REVIEW OF ENVIRONMENTAL FACTORS

Proposed Seniors Housing Development

289 – 293 Beauchamp Road, Matraville NSW 2036

March 2023

Figure 12 First-floor extract showing sited windows – First Level
(Source: Architectural Plans, CMA, dated 03/02/2023)

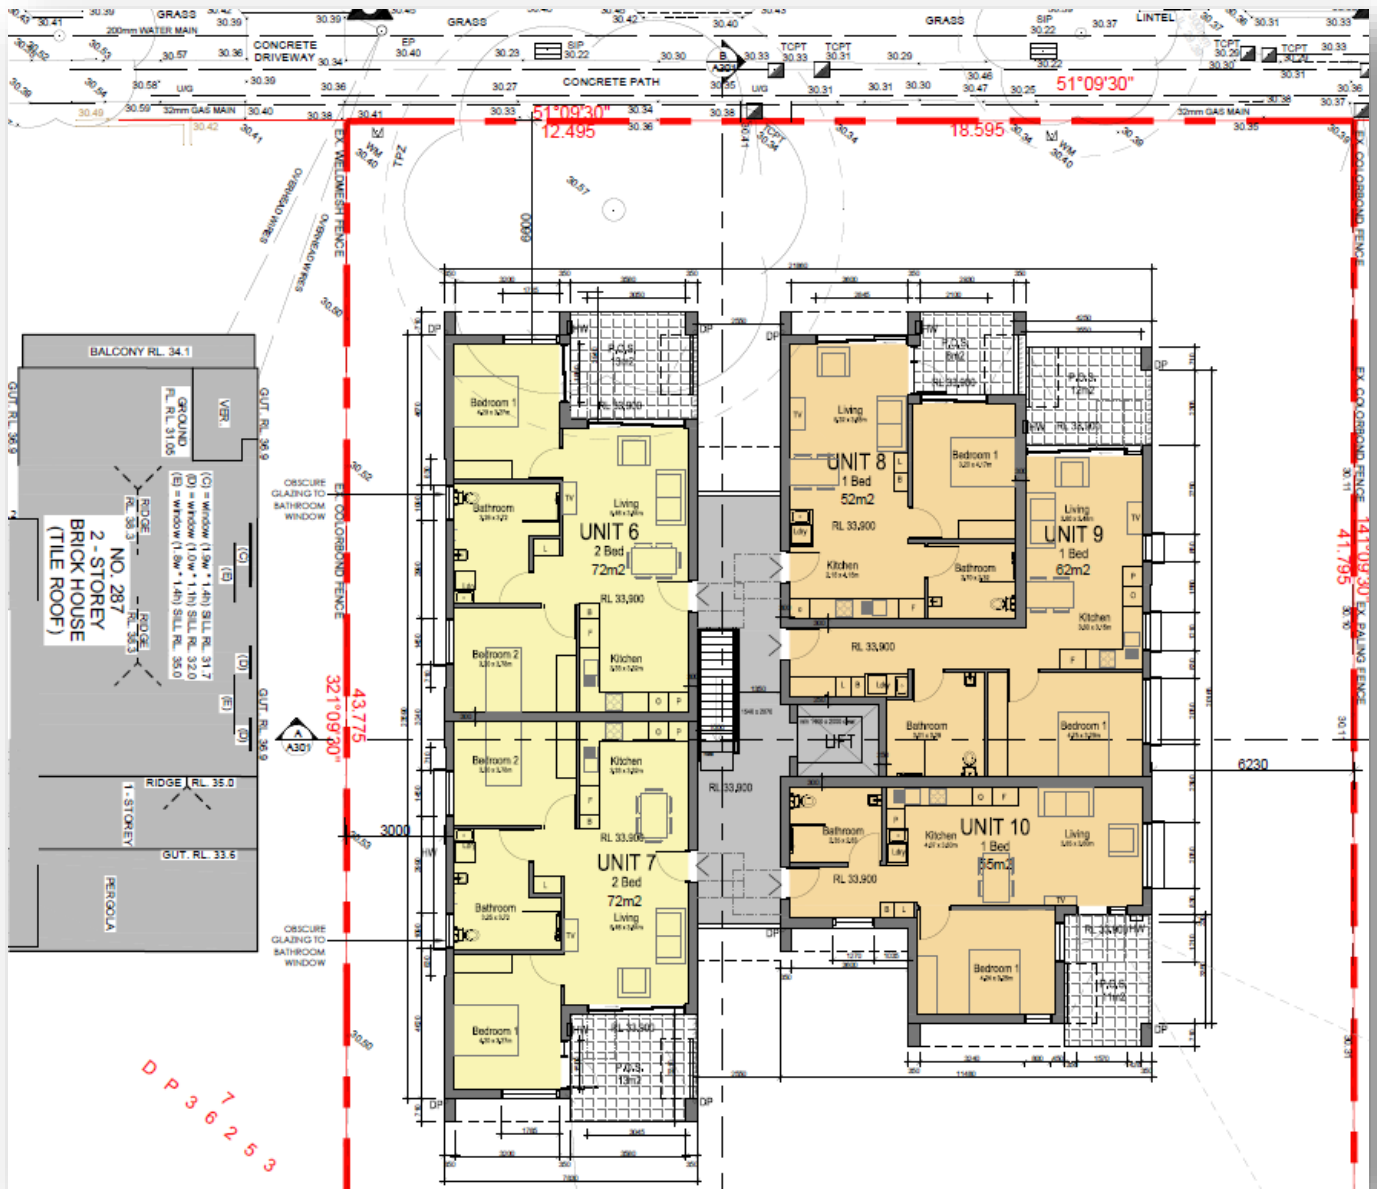
Issues raised	Response
<p><u>Privacy</u></p> <p>The property contains a number of windows at ground and first floors that have the potential to overlook adjoining properties to the east and west.</p> <p>Recommendation</p> <p>All habitable room windows facing side elevations at ground and first floor levels shall be provided with appropriate privacy measures (i.e. 1.6m sill height or privacy screen).</p>	<p>A number of amendments were made to the architectural plans in response to Council's privacy concerns. These include:</p> <ul style="list-style-type: none"> • Privacy screen to be extended around western side of Unit 1 POS (alongside boundary). • Existing Colorbond fence to be extended if required to meet privacy screen. • Side facing bathroom windows are to be translucent glazing. • Unit 5 privacy screen has been amended to be 1.6m high AFFL. • The living room window of Unit 10 has been amended to 2 double-hung windows (instead of the previously proposed slider) with obscure lower sashes. • Detail has been added to show actual size and orientation of proposed louvres – see A-123 for Unit 10 unit layout plan and detail. <p>It should also be noted that a row of Lilly Pillies (<i>Syzygium australe</i> 'Pinnacle') is proposed along both side boundaries. These are specified as 25L pots with a mature height of 6-10m. They are known to be a fast-growing species and suitable as hedge planting providing good privacy due to its dense foliage.</p> <p>Given the above amendments, and proposed screening landscaping, it is considered that the proposal provides an adequate privacy outcome that does not result in adverse overlooking impacts to adjoining properties.</p>

First-floor windows are limited to bedrooms and bathrooms, with the main living areas oriented to the rear of the site. The windows have been sited to avoid direct overlooking with the adjoining first floor windows, as shown in the extract below. The development, despite the non-compliance, is therefore not expected to result in unreasonable privacy impacts.
